WATTS BAR NUCLEAR PLANT (WBN) UNIT 1 - RESPONSE TO NRC QUESTIONS ON TVA'S
QA RECORDS CORRECTIVE ACTION PROGRAM (CAP) PLAN, REVISION 4

RESPONSE TO NRC QUESTIONS OF JANUARY 30, 1992

CONCERNING TVA'S QUALITY ASSURANCE RECORDS CAP (REVISION 4)

Figure 5. Bayes Examples on Log Scale

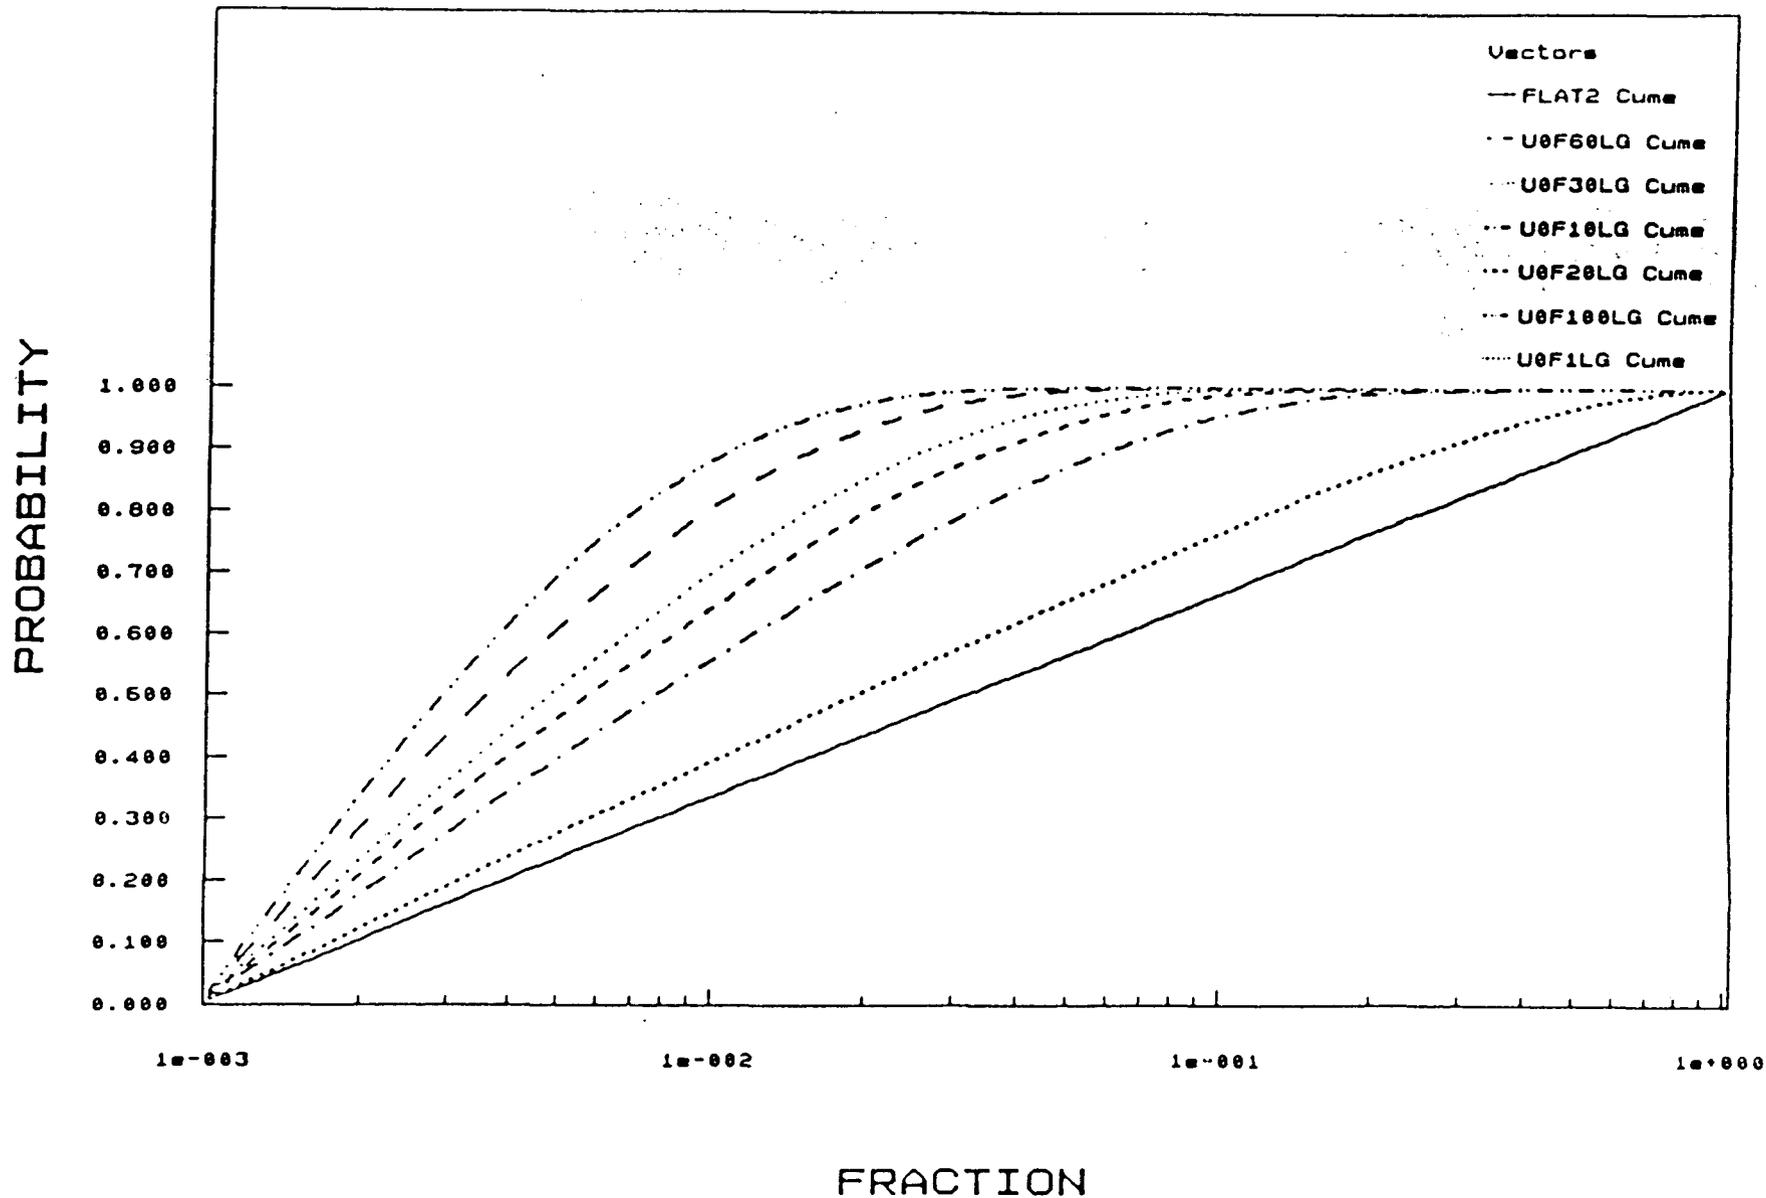
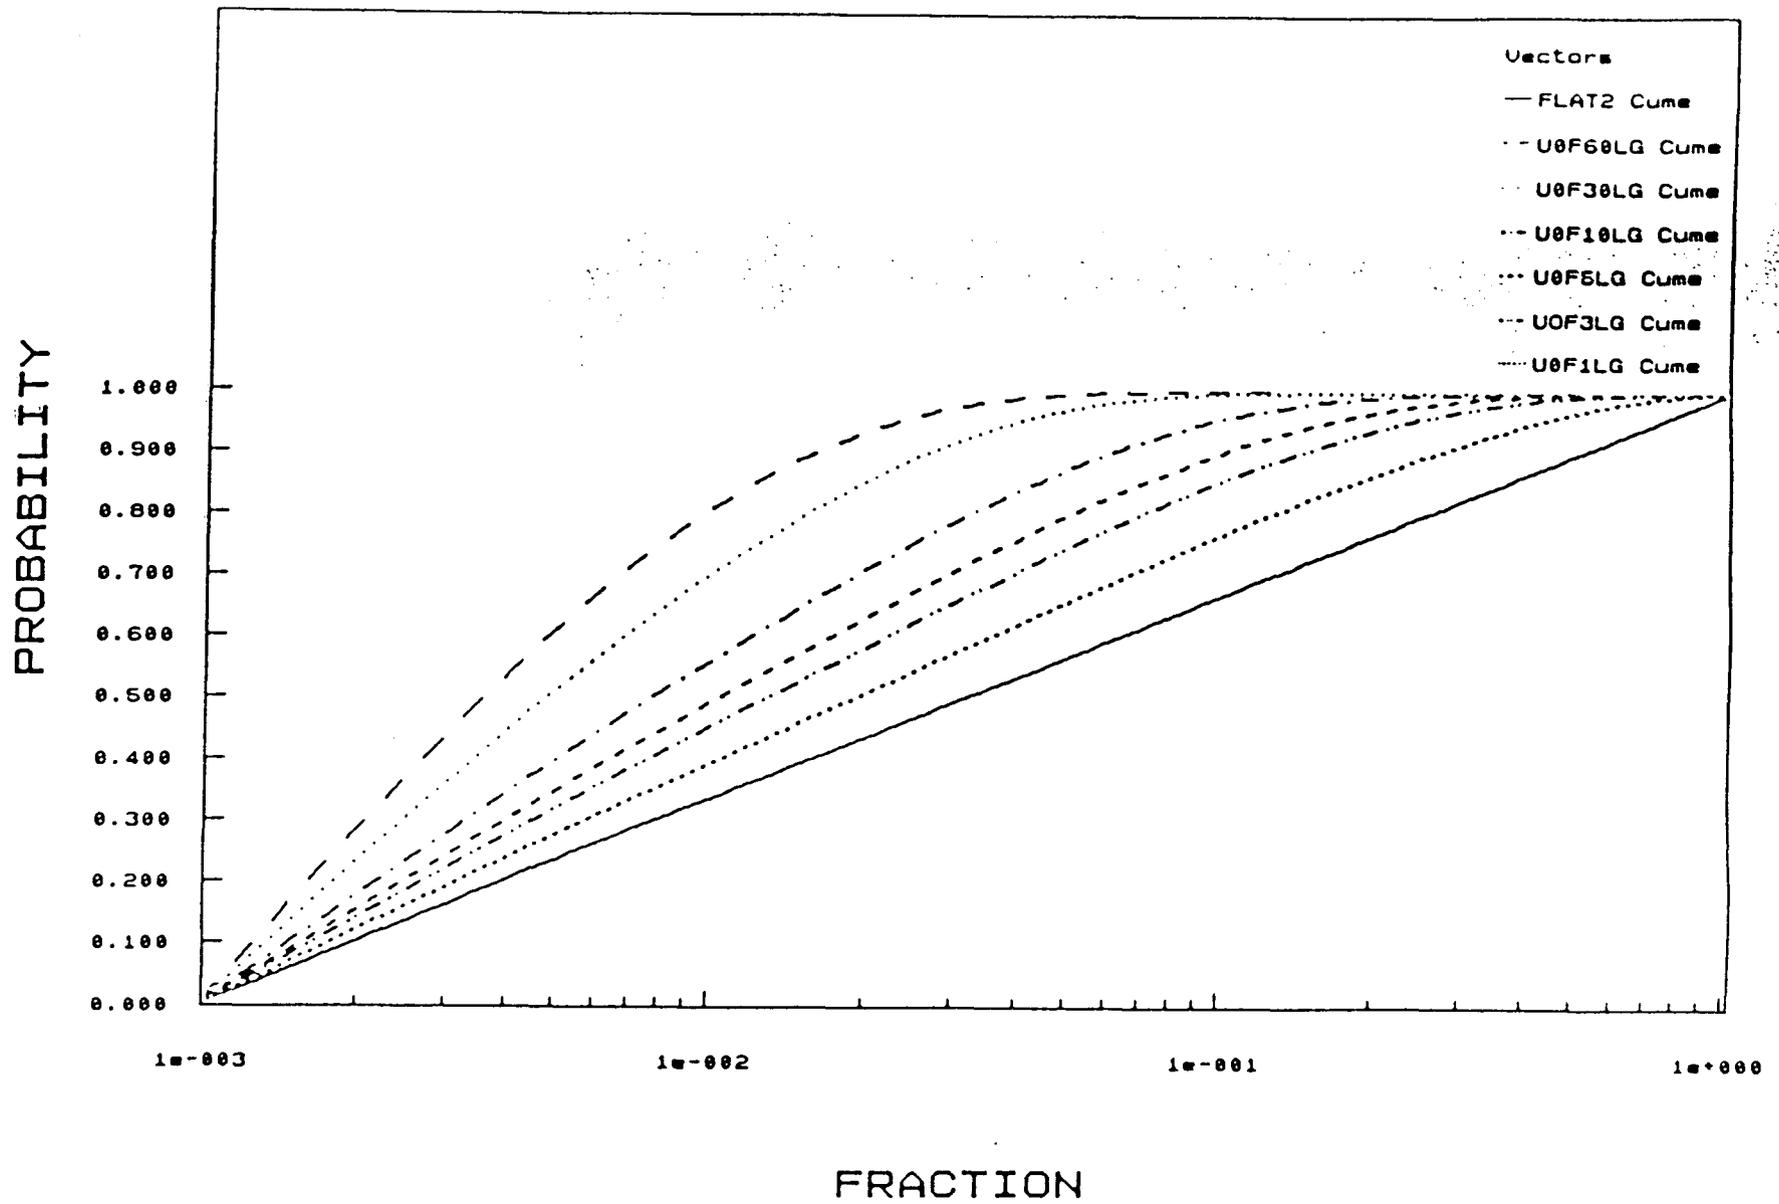
- (a) What is the justification for using a Bayesian as opposed to a standard classical approach?
- (b) What is the prior distribution of the defect fraction used to calculate the curves in Figure 2 of the reference? On what basis was it chosen?
- (c) What prior distributions will be used for the weighted average technique, and on what bases were they chosen?
- (d) What is the sensitivity of the results to the prior distributions used in (b) and (c) above?

With the classical prior and a sample of size 30, with zero defects, we have 95% confidence that the defect rate is below 9%. With the logarithmic prior we have 95% confidence that it is below 5%. Further results, using the flat logarithmic prior are given in Figures 5 and 6.
